Access Compliance Report

Public Rights-of-Way

Intersection ID: 19485	Main Street: MONIQUE_LN	Cross Street: PARK_RD	Location: NE
ADA ID: 17BB41899175	Ramp Type: PerpDiag	Initial Pass/Fail: Fail	Overall Compliance: No
		Severity Score: 12.5

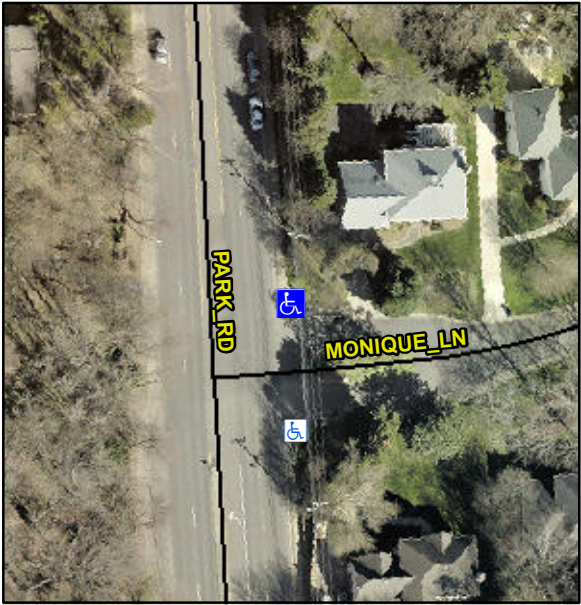
Codes/Mitigation Info/Possible Solution			Field Measurements/Component Compliance		
	Possible Solutions:		Compliance	Description	Data
	Remove & Replace Curb Ramp With Two New Directional Ramps or Equivalent.		No	Ramp Length (in)	62.0
			Yes	Ramp Width (in)	48.0
			N/A	Flare Type LT	N/A
			N/A	Flare Slope LT (%)	N/A
			N/A	Flare Traversable LT?	N/A
			N/A	Landing Length (in)	N/A
			N/A	Landing Width (in)	N/A
			N/A	Landing Slope (%)	N/A
			N/A	Landing X Slope (%)	N/A
			N/A	Landing Curb? (Y/N)	N/A
			N/A	Shared Landing?	N/A
			N/A	Gutter Ponding?	N/A
			N/A	Gutter Lip Ht (in)	N/A
			No	Painted X Walk1?	N/A
			To W	X Walk 1 Direction	N/A
			N/A	X Walk 1 Width (in)	N/A

6.7	X Walk 1 Slope (%)	N/A
			1.8	X Walk 1 X Slope (%)	N/A
			N/A	Ramp inside XWalk1?	N/A
<p>Surveyor Notes:</p> <p>N/A</p> <p>PROW/ADA:</p> <p>Not Found, R304.2.2</p>			N/A	Flare Type RT	N/A
			N/A	Flare Slope RT (%)	N/A
			N/A	Flare Traversable RT?	N/A
			N/A	DWS Provided?	N/A
			N/A	DWS Contrast?	N/A
			N/A	DWS Length (in)	N/A
			N/A	DWS Full Width?	N/A
			N/A	DWS Offset (in)	N/A
			N/A	Gutter Slope (%)	N/A
			N/A	Gutter X Slope (%)	N/A
			No	Painted X Walk2?	N/A
			To S	X Walk 2 Direction	N/A
			N/A	X Walk 2 Width (in)	N/A
